Device Errata for the MPC850 Family

This document is a compilation of all MPC850 family device errata from silicon Revision 0.0 forward. Herein, the errata are classified and numbered, and each erratum is provided with a description and workarounds.

G4 Potential problems caused by skew between EXTCLK and CLKOUT

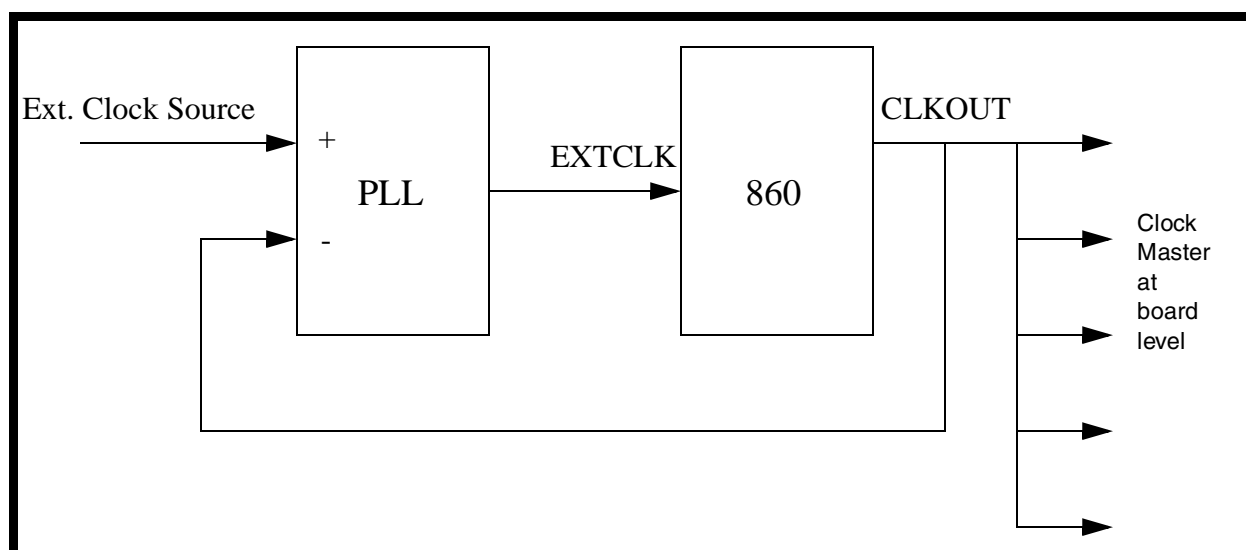
Description:

In correct operation, the PLL of the MPC850 will lock on the rising edge of the input clock. However, on these revisions of the MPC850, the PLL may lock on the falling edge of the input clock. This will affect the skew between EXTCLK and CLKOUT at the rising edge. The skew is dependent on the duty cycle of the input clock (but for a 50% duty cycle will not exceed 2nS). This will affect synchronous designs where the same clock source is used as an input to EXTCLK, as well as to an external synchronous device (for example, a peripheral or ASIC).

Insert a PLL between the external master clock and the EXTCLK pin of the MPC850. Connect the phase comparison pin of the PLL to the CLKOUT pin of the MPC 860. Also use the CLKOUT signal as the reference clock for distribution to the local external peripherals.

Important Note: The PLL has to be capable of operating with a permanent offset of -2nS, therefore the range of lock should extend to about -4nS.

A diagram of this concept is given below:
